**AUTHORIZING THE CITY MANAGER TO ENTER INTO A DEVELOPMENT AGREEMENT AND OTHER RELATED AGREEMENTS FOR THE DEVELOPMENT OF THE INDUS BRIDGE STREET DEVELOPMENT WITH INDUS COMPANIES, INC. AND THE DAIMLER GROUP, INC.**

**2. Indus Bridge Street at PIDs: 273-012427, 273-012430, 273-012429, 273-008244, 273-009080, 273-009101 22-172CP**

**Concept Plan**

## **2. Indus Bridge Street at PIDs: 273-012427, 273-012430, 273-012429, 273-008244, 273-009080, 273-009101, 22-172CP, Concept Plan**

## RECORD OF ACTION

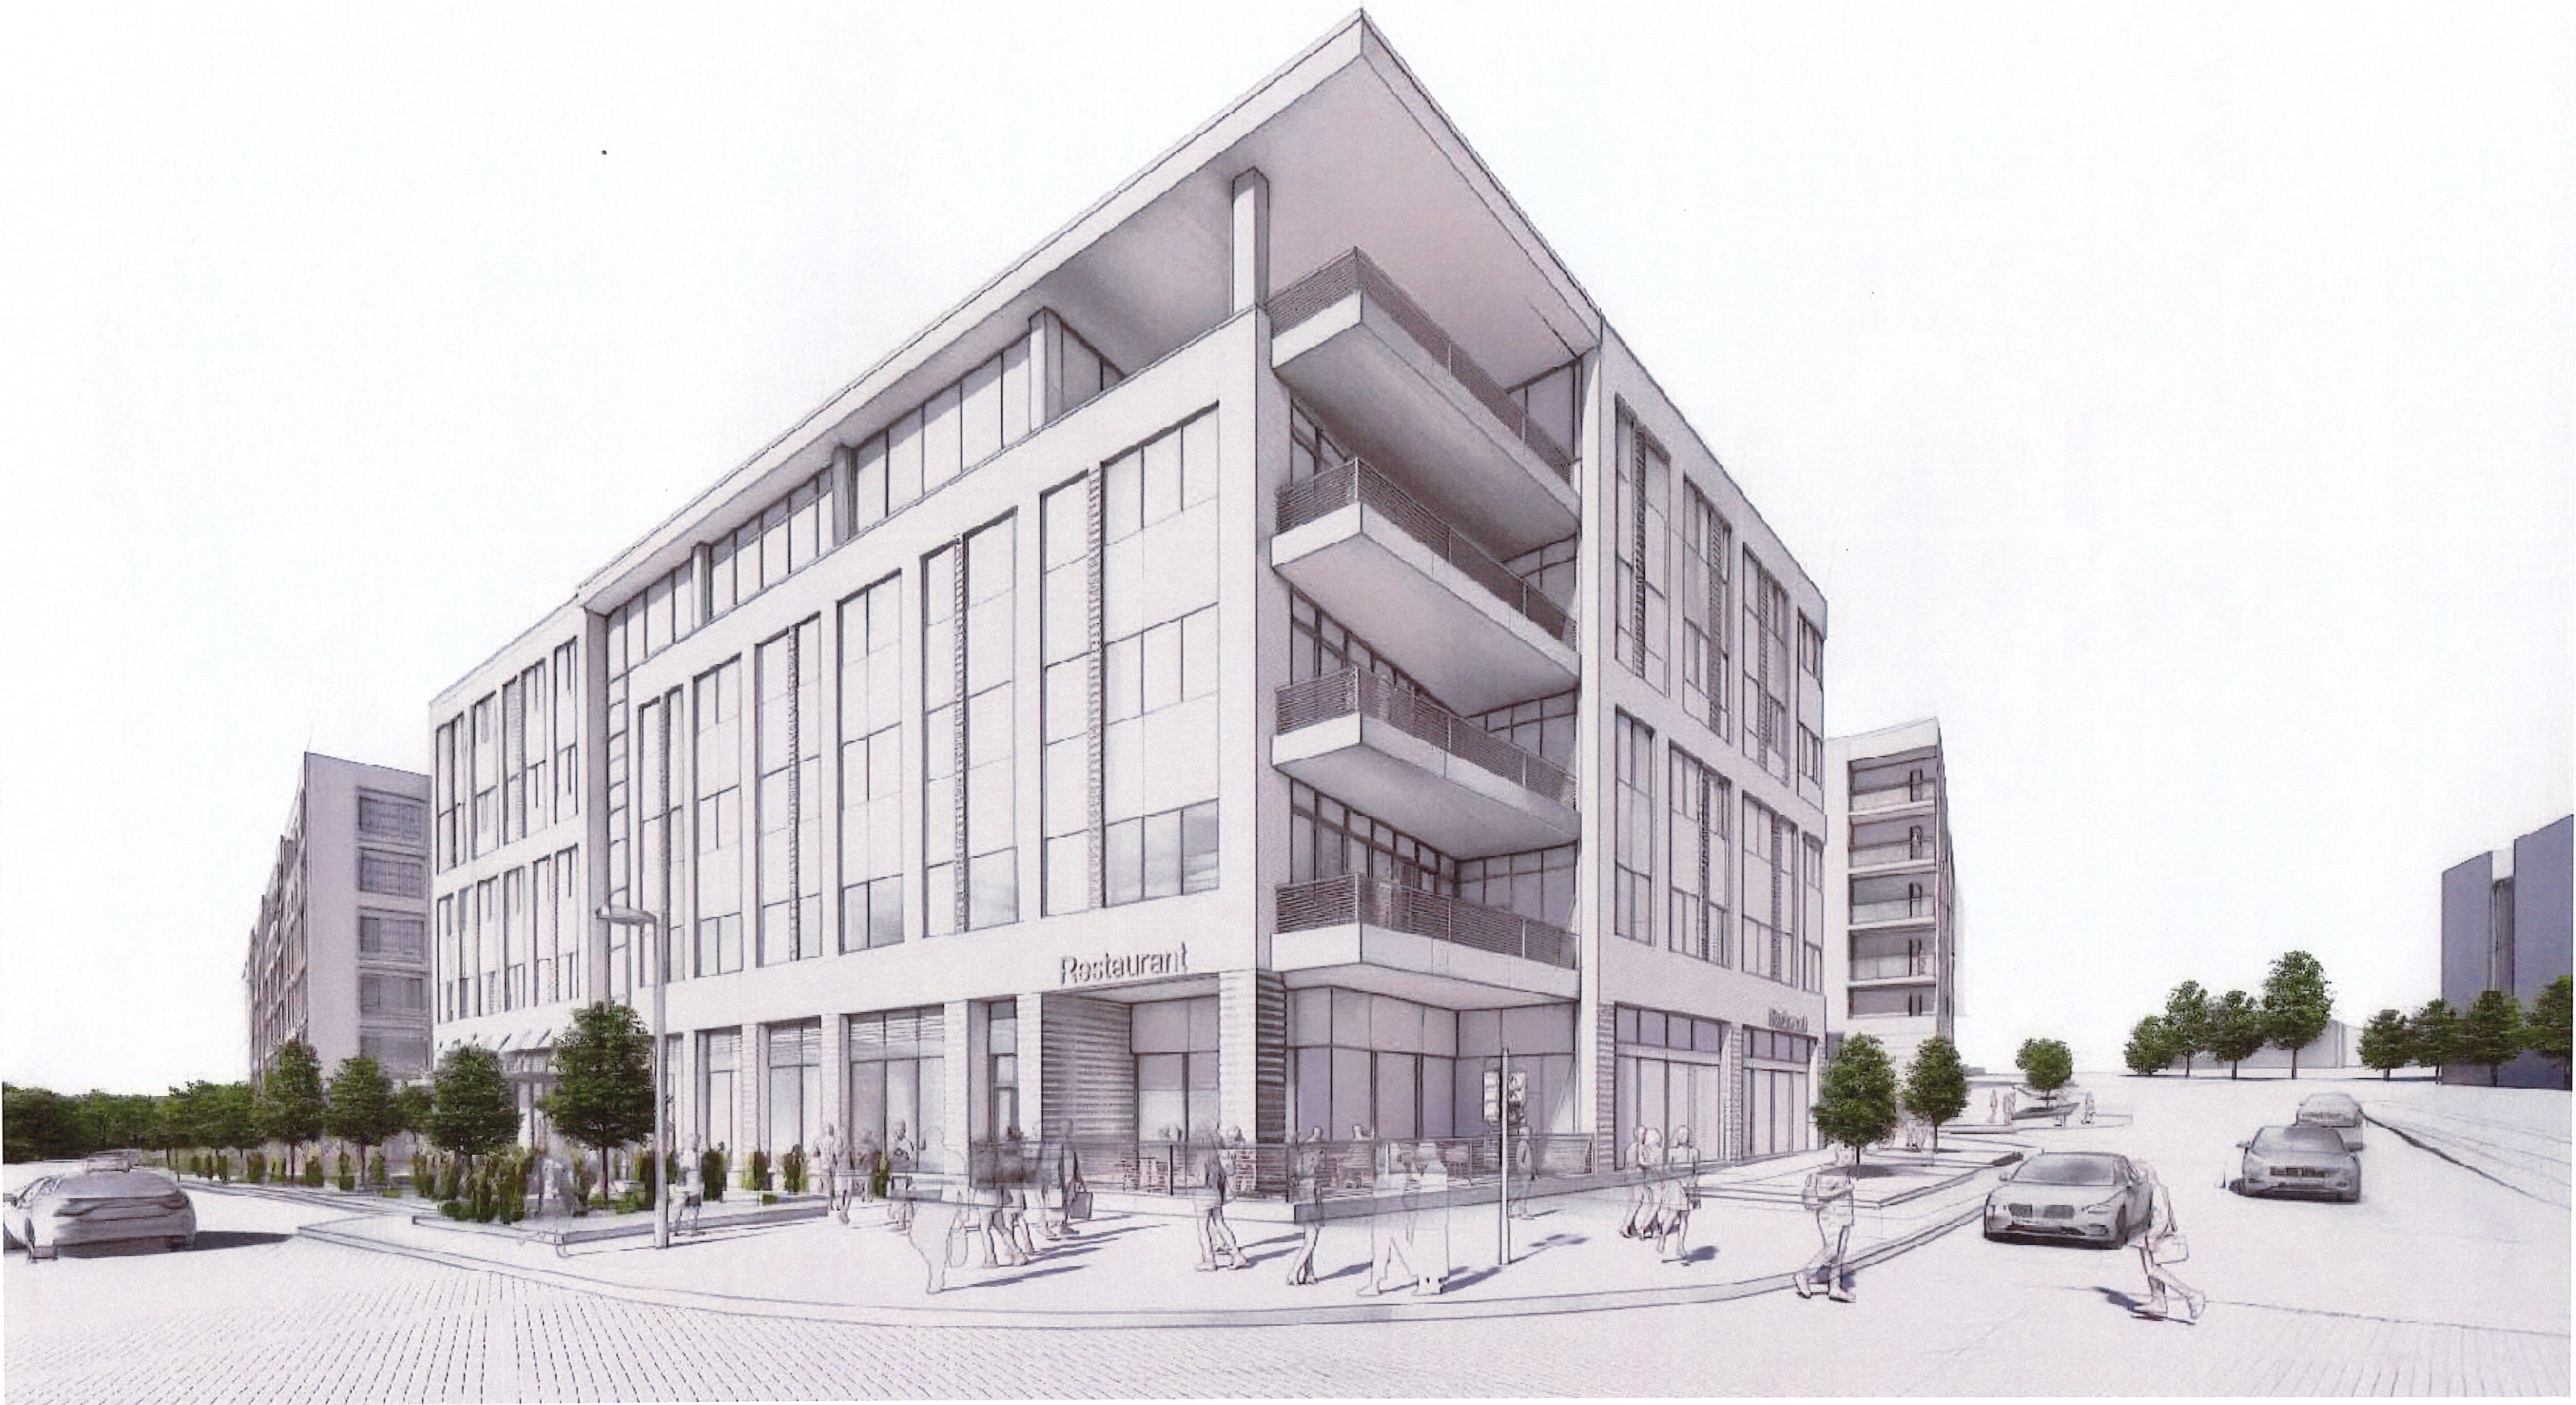
- 1) The applicant consolidate the number of hotel and garage access points and align with the existing access points on the east side of Mooney Street, to the satisfaction of the City Engineer;

- 2) The applicant provide access to the garage from Longshore Street, to the satisfaction of the City Engineer;
- 3) The applicant reduce the massing of the buildings to meet the Code and to complement the existing character of the Scioto River Neighborhood;

- 4) The applicant identify opportunities to reduce the amount of parking spaces and size of the parking structure to meet the Code, which could include investigating shared parking opportunities throughout the Scioto River Neighborhood District;

- 5) The applicant work with staff to provide additional design details with subsequent applications to provide unique gateway designs at the key intersections that align with the requirements of the Scioto River Neighborhood;

- 6) The applicant submit a Traffic Impact Study at a future time determined by staff;
- 7) The applicant continue to work with staff to ensure the heights of the buildings meet the Code and are compatible with the intent and existing buildings of the Scioto River Neighborhood, subject to staff approval;

- 8) The applicant work with staff to ensure unique, high quality architectural design and details are incorporated within the proposed development that complements the district; and
- 9) The applicant identify additional opportunities to activate the north elevation of the garage along Tuller Road.
